Access Compliance Report

Public Rights-of-Way

Intersection ID: 43513	Main Street: BLACKBERRY RIDGE LN	Cross Street: MULBERRY POND DR	Location: SW
ADA ID: D6B825D8D638	Ramp Type: PerpDiag	Initial Pass/Fail: Fail	Overall Compliance: No
Severity Score: 10			
Codes/Mitigation Info/Possible Solution		Field Measurements/Component Compliance

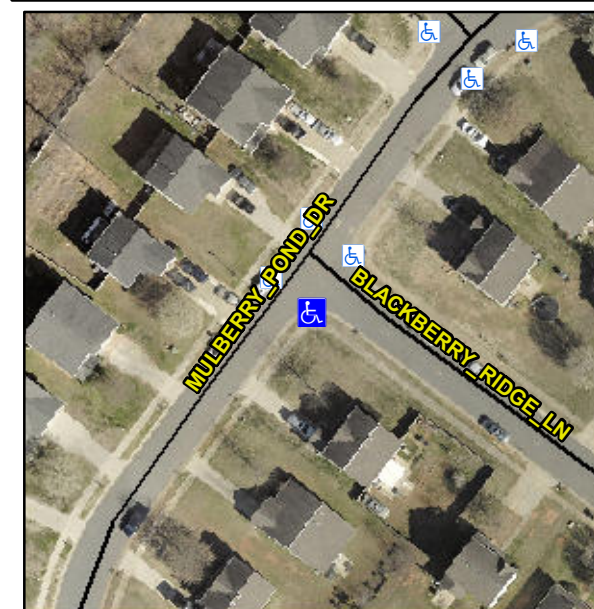
Not Found, R304.5.1, R304.5.3

Compliance	Description	Data	Compliance	Description	Data
N/A	Ramp Length (in)	46.0	Yes	Ramp Slope (%)	6.0
No	Ramp Width (in)	40.5	No	Ramp XSlope (%)	3.0
N/A	Flare Type LT	N/A	N/A	Flare Type RT	N/A
N/A	Flare Slope LT (%)	N/A	N/A	Flare Slope RT (%)	N/A
N/A	Flare Traversable LT?	N/A	N/A	Flare Traversable RT?	N/A
N/A	Landing Length (in)	N/A	N/A	DWS Provided?	N/A
N/A	Landing Width (in)	N/A	N/A	DWS Contrast?	N/A
N/A	Landing Slope (%)	N/A	N/A	DWS Length (in)	N/A
N/A	Landing X Slope (%)	N/A	N/A	DWS Full Width?	N/A
N/A	Landing Curb? (Y/N)	N/A	N/A	DWS Offset (in)	N/A
N/A	Shared Landing?	N/A			
N/A	Gutter Ponding?	N/A	N/A	Gutter Slope (%)	N/A
N/A	Gutter Lip Ht (in)	N/A	N/A	Gutter X Slope (%)	N/A
N/A	Painted X Walk1?	No	N/A	Painted X Walk2?	No
	X Walk 1 Direction	To NE		X Walk 2 Direction	To NW
N/A	X Walk 1 Width (in)	N/A	N/A	X Walk 2 Width (in)	N/A
	X Walk 1 Slope (%)	0.4		X Walk 2 Slope (%)	1.7
	X Walk 1 X Slope (%)	0.7		X Walk 2 X Slope (%)	1.3

Remove & Replace Curb Ramp With Two New Directional Ramps or Equivalent.
